SUSQUEHANNA RIVER BASIN COMMISSION
5012 LENKER STREET
MECHANICSBURG, PENNSYLVANIA 17055

STAFF REVIEW
OF
PROPOSED
WYOMING VALLEY PROJECT

WORKING DRAFT

JANUARY 9, 1974

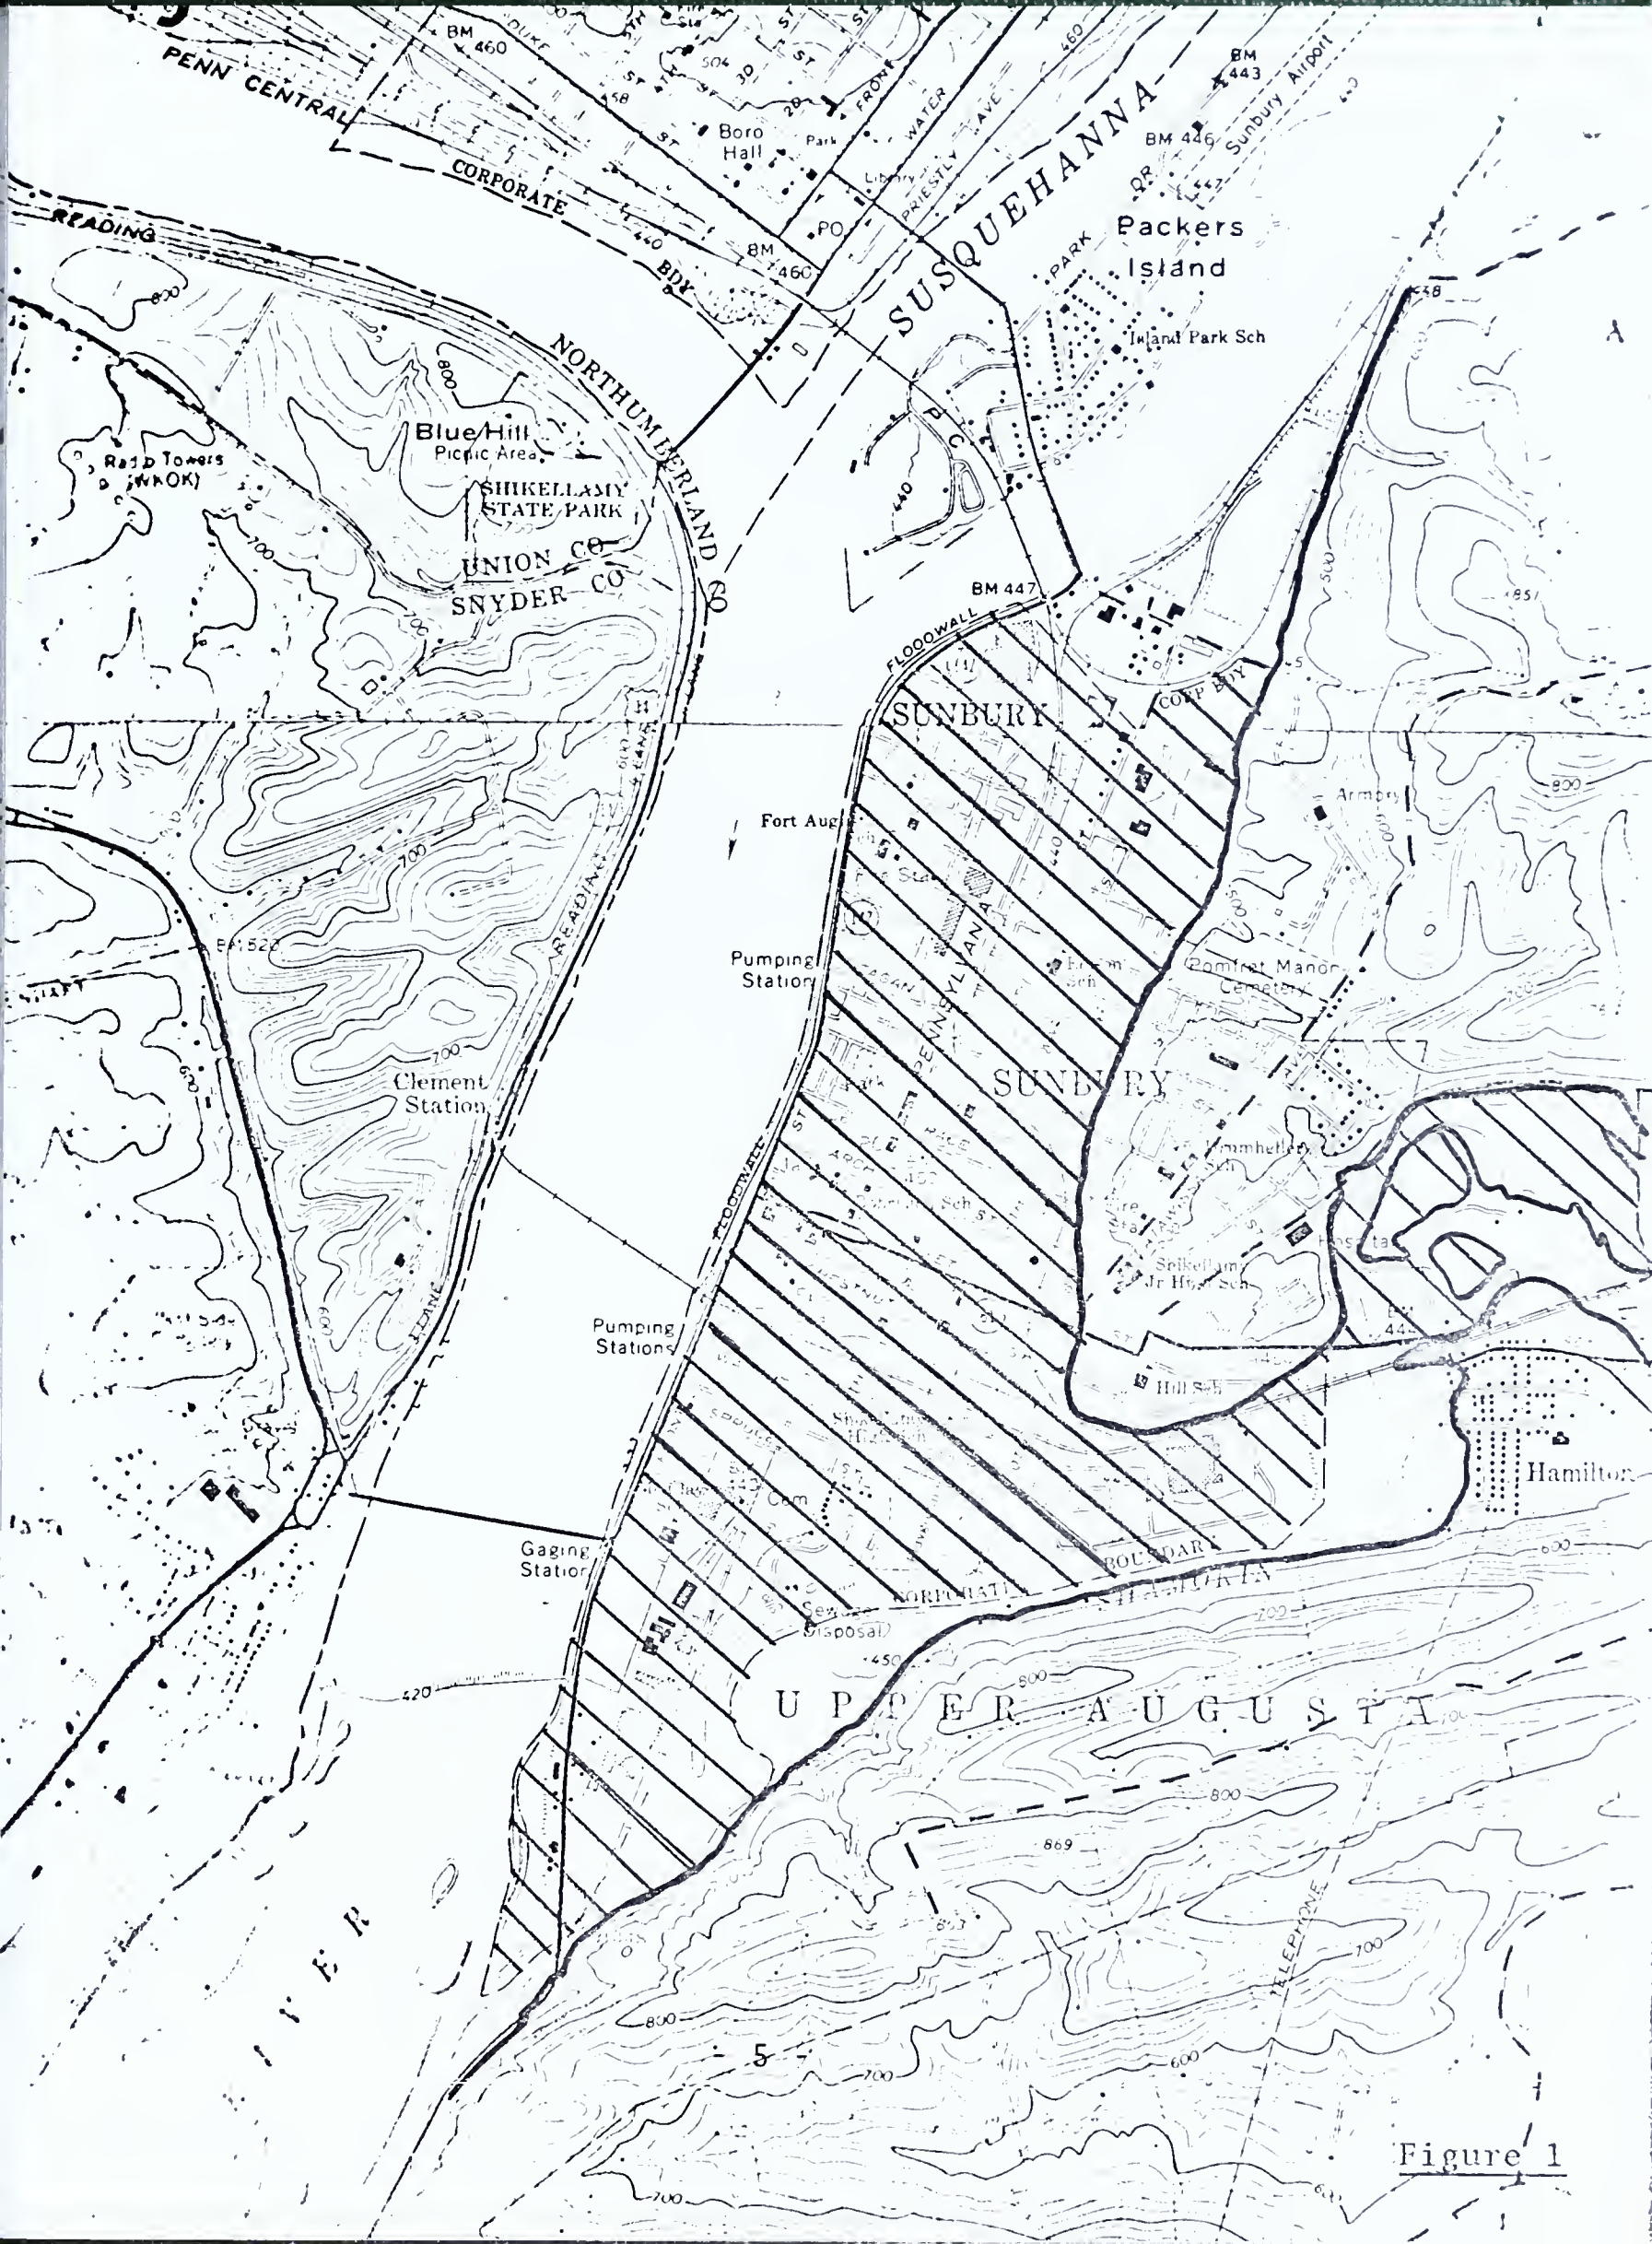
a) Sunbury--The Corps of Engineers' study of the Agnes flood indicates that if the Wilkes-Barre levees had not breached, the discharge at Sunbury would have been 71,000 cfs higher. Because of uncertainty in the rating curve, the exact increment of stage is uncertain, but is estimated to be between 1.8 and 3.2 feet. Using the smaller value, the resulting water level elevation would be 452 at the south end of town and 456 at the north end of town. According to the Assistant City Engineer at Sunbury, the Agnes peak was within 0.5 feet of the top of the levee at the north end of town, and within 0.25 feet of the top of the wall between the Bainbridge Street bridge and the Reading Railroad bridge.

Thus, it seems reasonable to expect that the levee would have been topped and probably breached by the additional flow, and there would have been flow over the wall. It also seems reasonable to expect that Sunbury would have been inundated to approximately elevation 452 had the Wilkes-Barre levees held. Exhibit 1

delineates the area of the City of Sunbury that would be inundated by water at this elevation. Table 2 reflects the number of structures, by type, that would be subject to flood water damage.^a
